Product Change Notification: P-23-025013

General Product Description:
Power FA Relay V23136. Change of cover marking from InkJet to Laser marking

Power-FA Marking – Non OEM

Actual Situation vs Future Situation

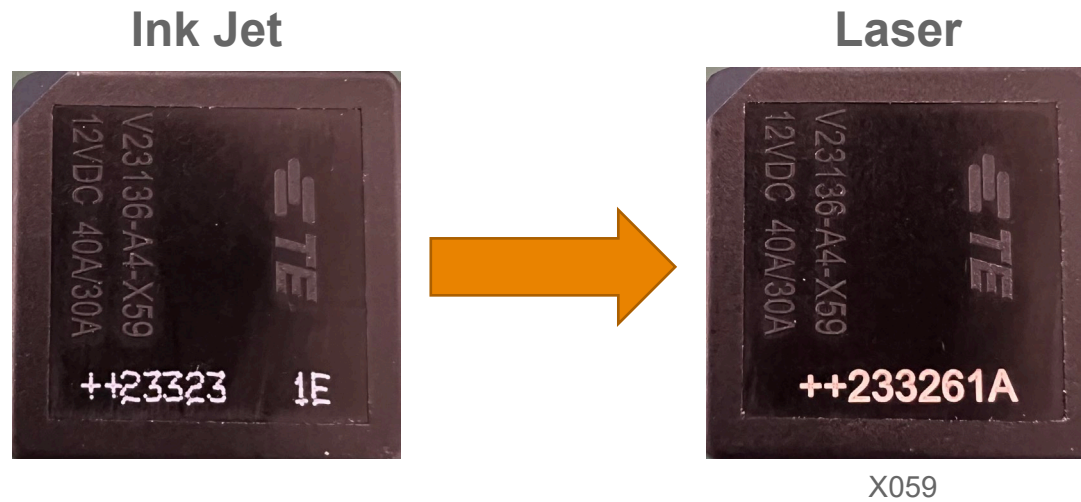
Ink Jet

- Black & White equipment according covers color
- Ink Jet and solvent are flammable and irritant to skin, throat and lungs - Safety

Laser

- Technology improvement that ensures more stability in the marking process
- Better marking quality
